## CPED STAFF REPORT

Prepared for the Heritage Preservation Commission  
HPC Agenda Item #3  
July 28, 2015  
BZH-28744

*Property Location:* 200 1<sup>st</sup> Street North  
*Project Name:* 200 1<sup>st</sup> Street North  
*Prepared By:* Aaron Hanauer, Senior City Planner, (612) 673-2494  
*Applicant:* The Daft Group, Eric Dayton  
*Project Contact:* James Dayton Design, Robert Hunter  
*Ward:* 3  
*Neighborhood:* North Loop  
*Request:* To rehabilitate the Northwestern Hide and Fur Building  
*Required Applications:*

<b>Certificate of Appropriateness</b>	To allow the rehabilitation of the Northwestern Hide and Fur Building
---------------------------------------	---

**PROPOSED SIGNAGE FOR 1ST ST. N. FACADE**  
SCALE: 3/4" = 1'-0"

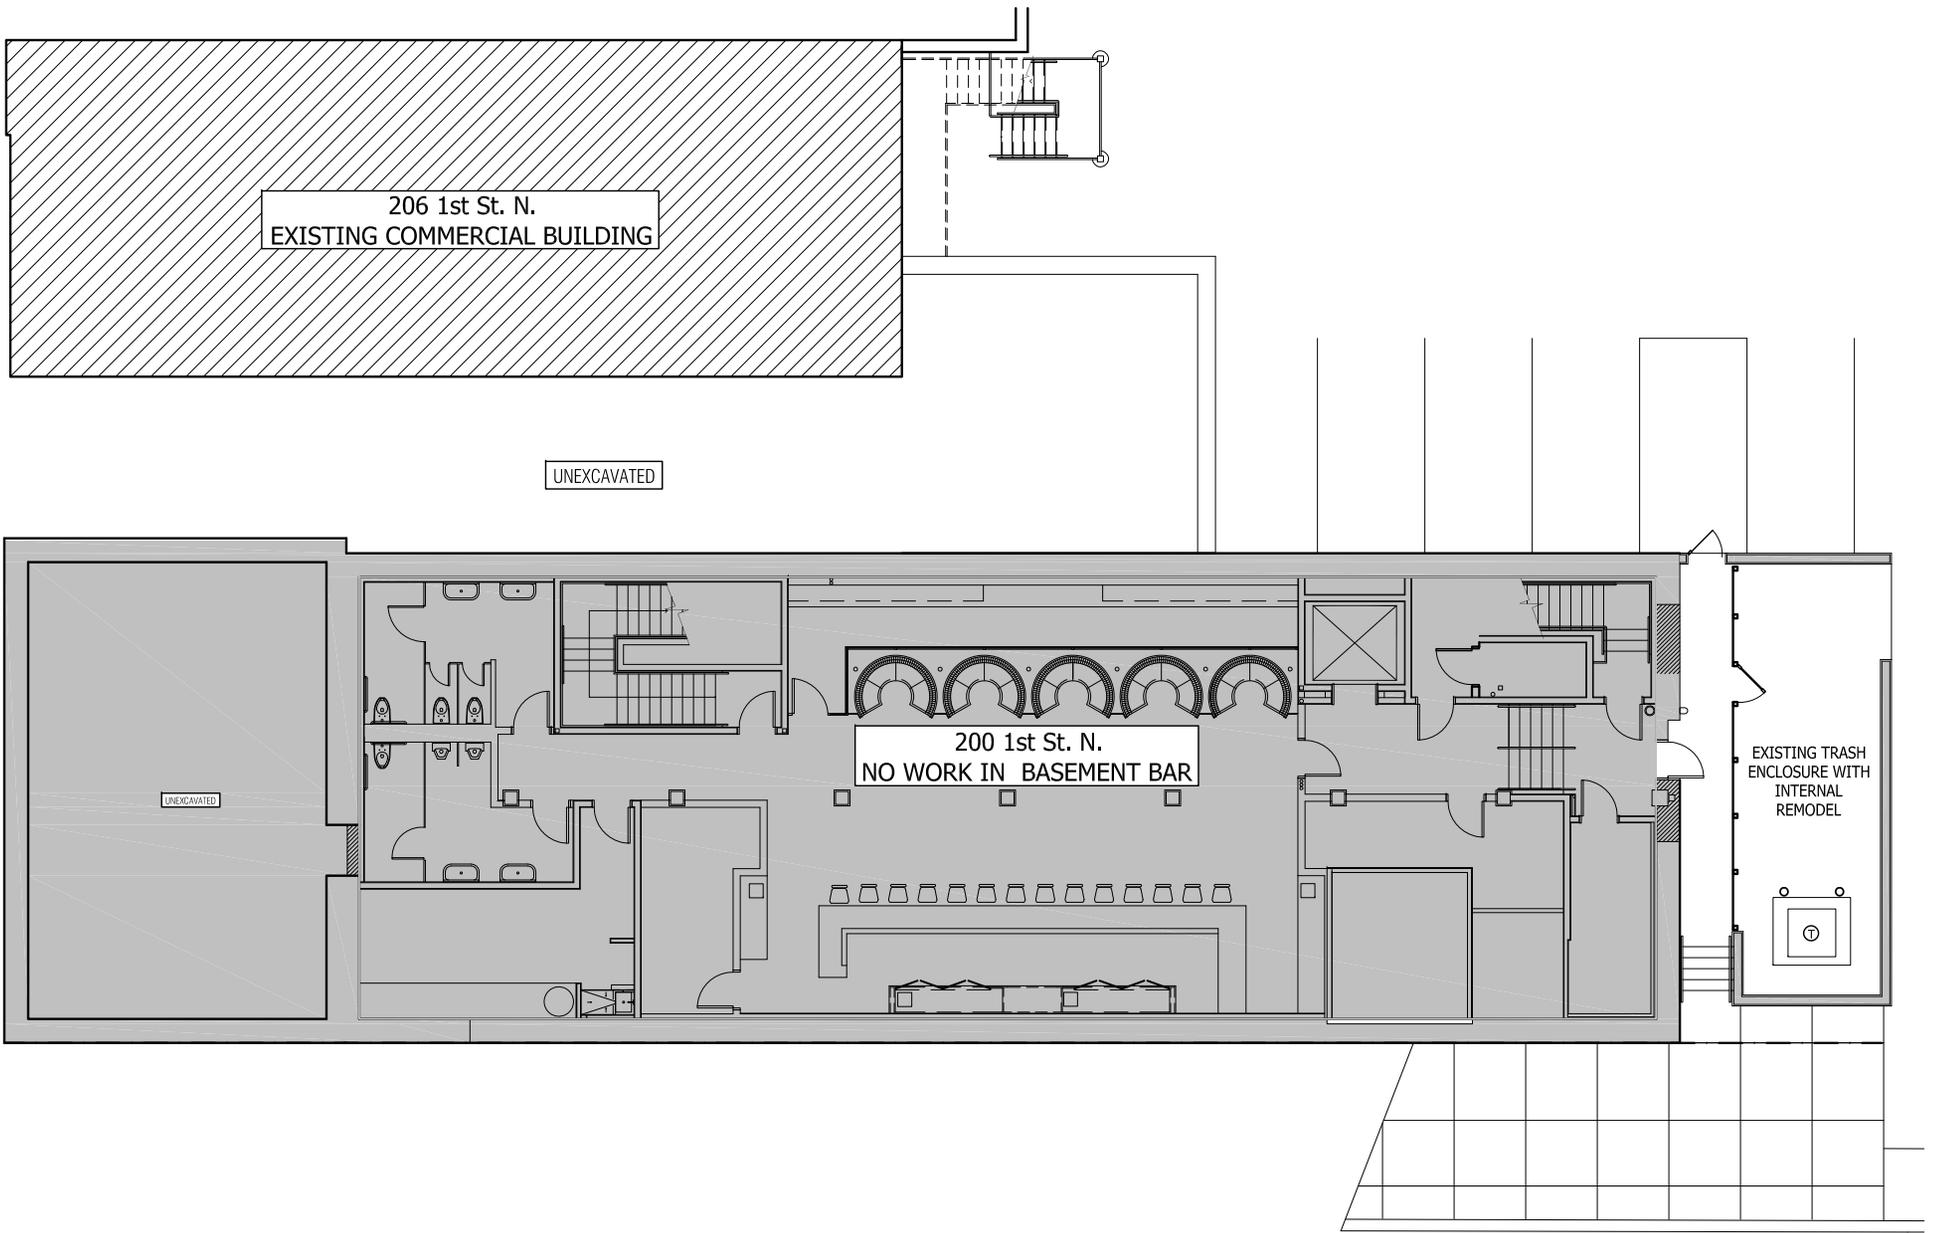
The applicant is proposing a three-square foot projecting sign that will replace an existing three-square foot projecting sign just to the left of the main entrance along 1<sup>st</sup> Street North. The sign would be in the same location as the existing sign. It will read “TBF Café” and will be internally illuminated with white translucent acrylic lettering and a dark grey opaque acrylic background. The sign will have a dark bronze aluminum frame/surround.
